TAX PARCEL ID: 077.19-01-16.00-0000
CURRENT ZONING: C2 - GENERAL COMMERCIAL
PROPOSED USE: SEE APPROVED SITE PLAN BY SUMMIT STUDIO, LLC FOR ZONING DETAILS AND COMPLIANCE.
PLAN PROVIDED HEREON IS FOR NEW WATER AND SEWER SERVICE CONNECTION ONLY.
SITE ACREAGE: 3.475 ACRES

THIS PLAN IS FOR WATER AND SEWER CONNECTION SERVICES TO THE PROPOSED COFFEE KIOSK. ADDITIONAL SITE IMPROVEMENTS RELATING TO COFFEE KIOSK ARE SHOWN PER APPROVED SITE PLAN BY SUMMIT STUDIO LLC.

Asbuilt

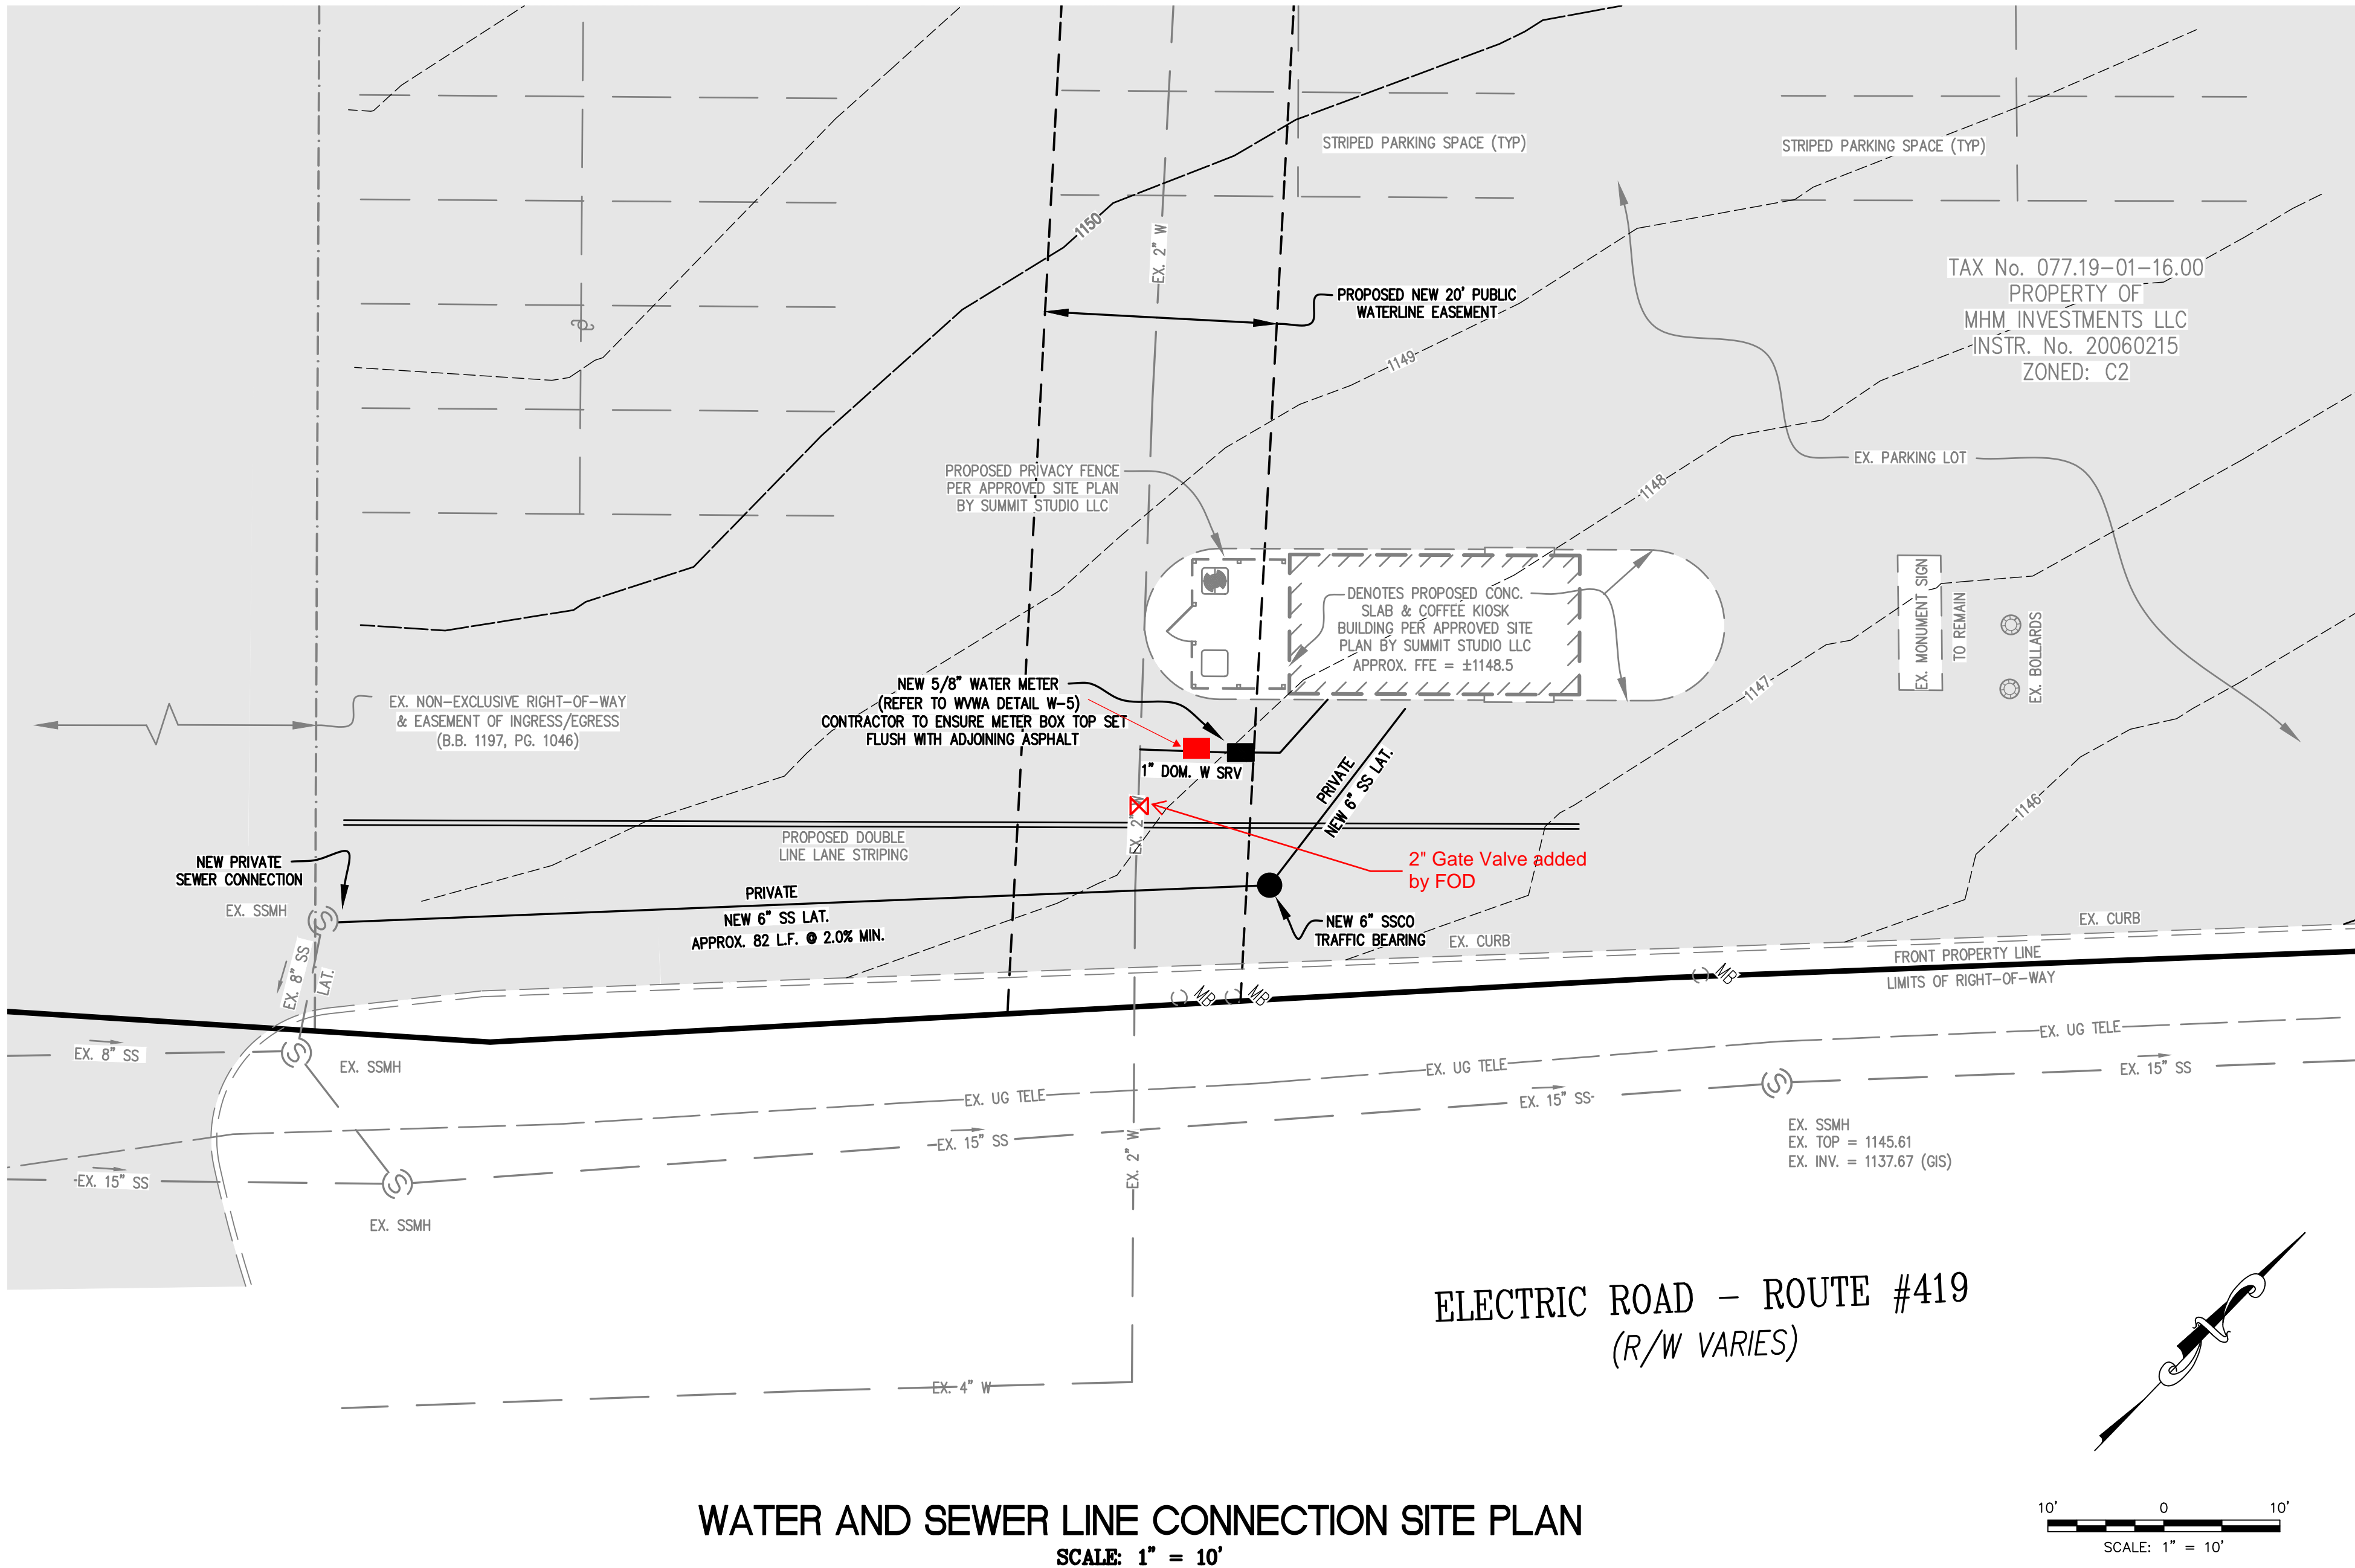
1" Polyflex Endot Service -

W5 Detail with 5/8x3/4

7" setter with check

Curb stop before setter in Square Traffic Rated
Meter box- See sheet 3 for submittal sheet

2" Gate valve installed by FOD during tap install
- FOD has material list for 2 inch valve
